Norwich Research Park South

Norfolk and Norwich University Hospital Roundabout

NNUH ROUNDABOUT S278
GENERAL ARRANGEMENT

60712988-ACM-RD-XX-DR-CE-40-0001

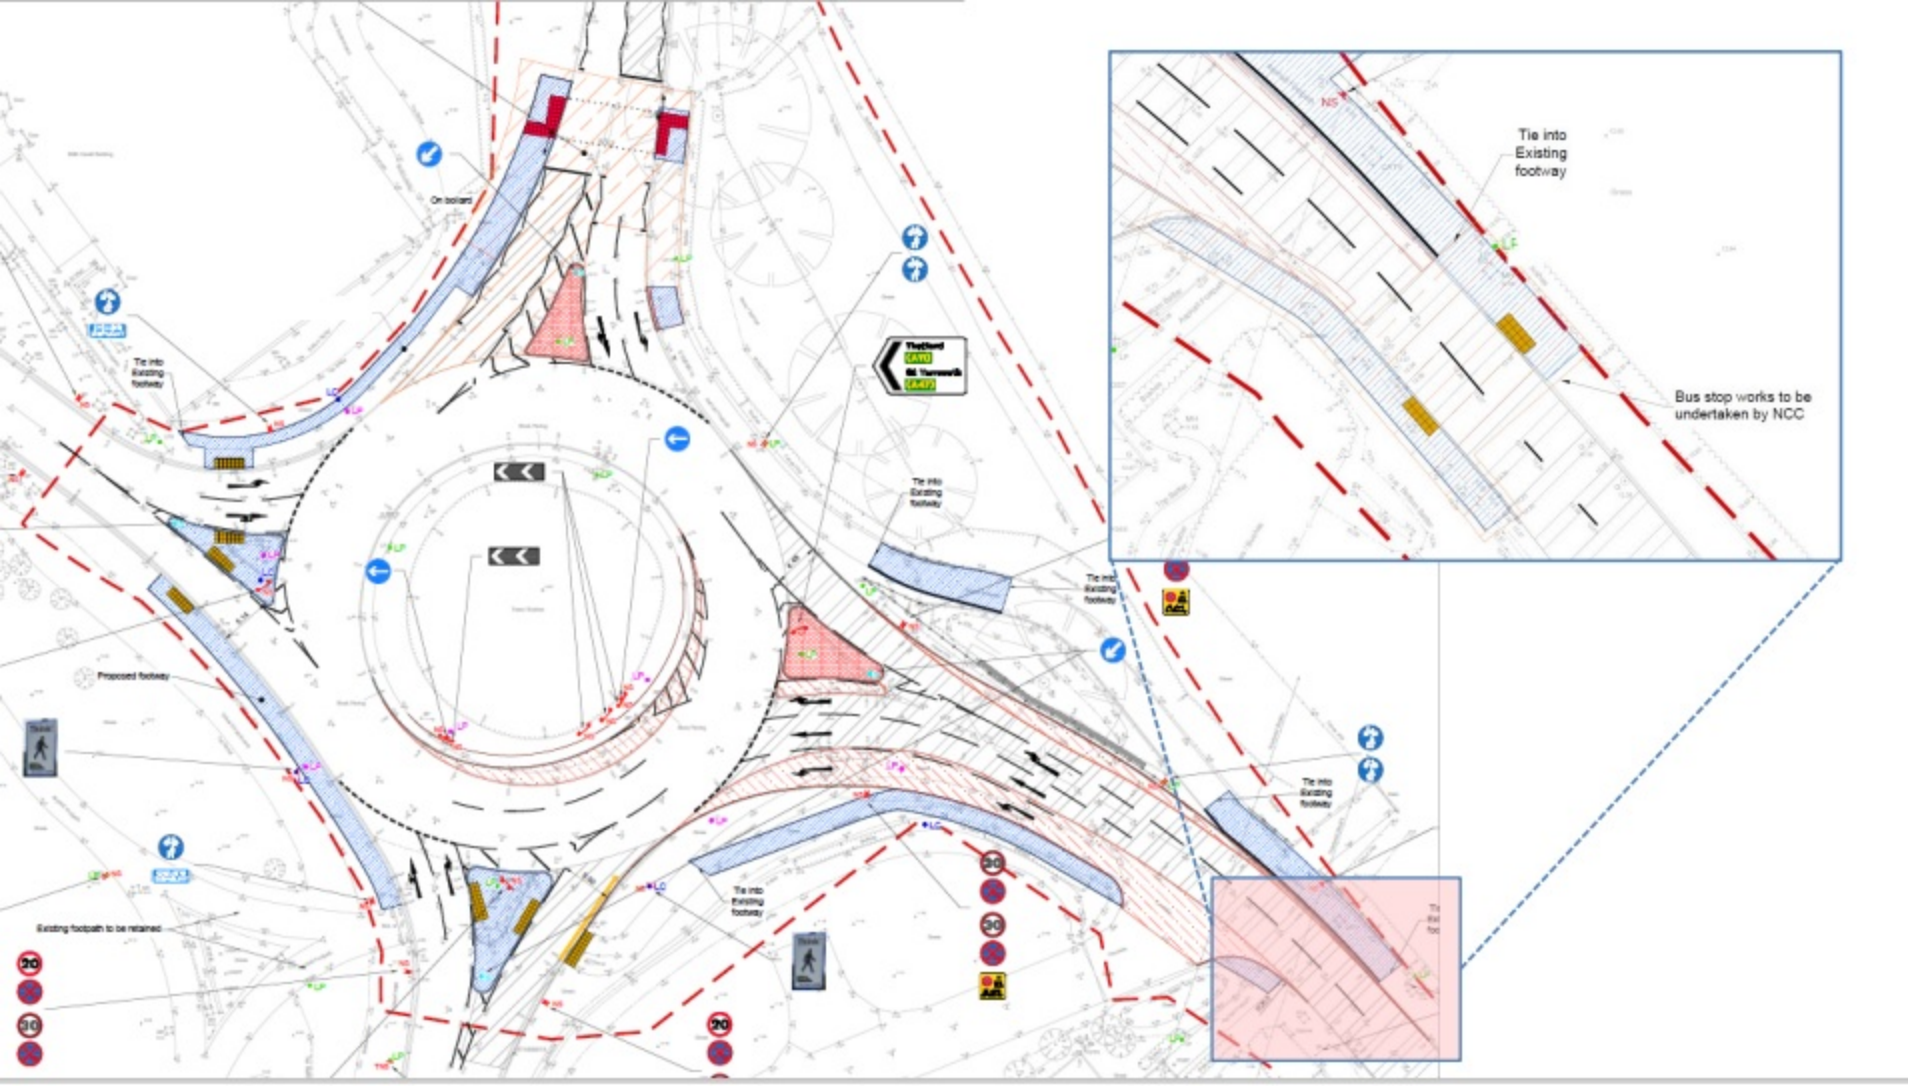
The hatched area will be the responsibility of NCC with the following caveat:

The area will require a contribution towards the lining cost where that lining is required by the roundabout improvement.

The proposed amendment to scope delivers that which would be required under planning conditions if the toucan crossing were not being installed.

UNDER REVIEW BY NNUH

Position of Highway Boundary to be confirmed
